NEW
RIVER

Burgess Hill

Design & Access Addendum

Proposed Section 73 Amendments

Proposed Landscaping Plan - Level 01

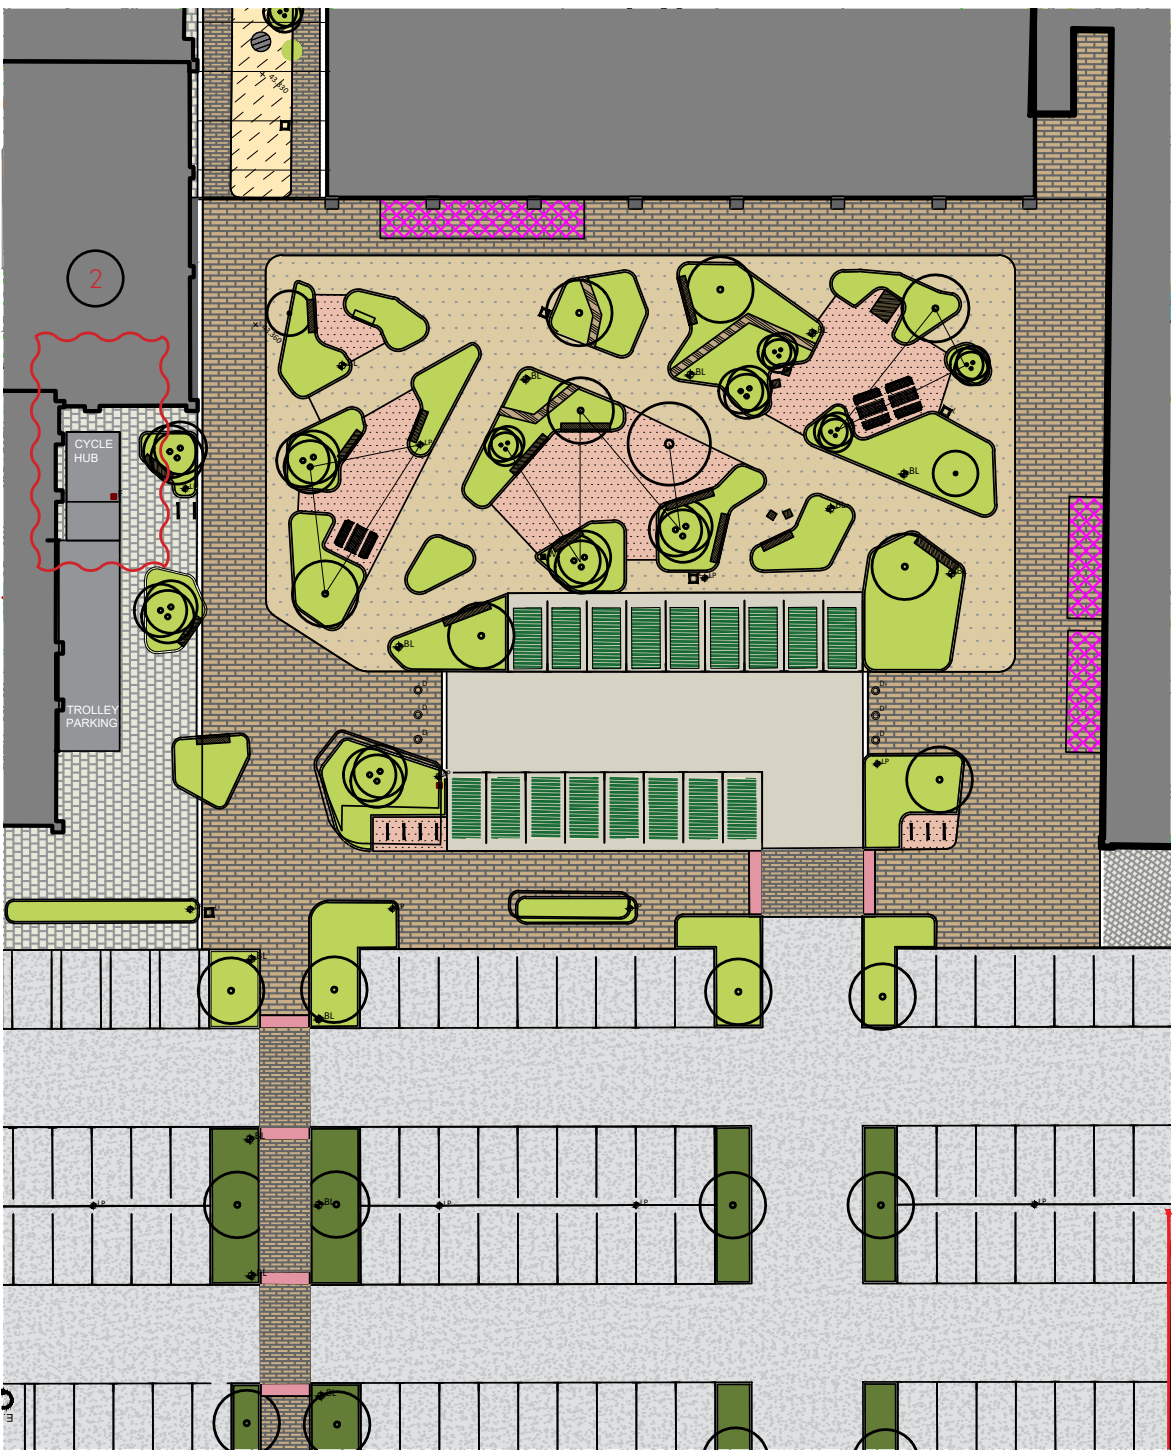
- 1. The consented application included public bicycle stands on the public square outside of the south western boundary of Block B. The revised application proposes relocating the Sheffield stands to various locations with the public realm with key consideration to the cycle networks.
- 2. Following matters raised in the West Sussex County Council Consultation regarding highways, a letter dated 22.04.2020 was submitted by WSP on behalf of our client New River REIR (UK) Limited committing to the delivery of a new Cycle Hub. As part of this revised submission a Cycle Hub is now proposed on the north western end of Church Walk where there is an existing planter bed. The cycle hub will connect to the proposed cycleway enhancements as part of a gateway entry to the Town Centre.
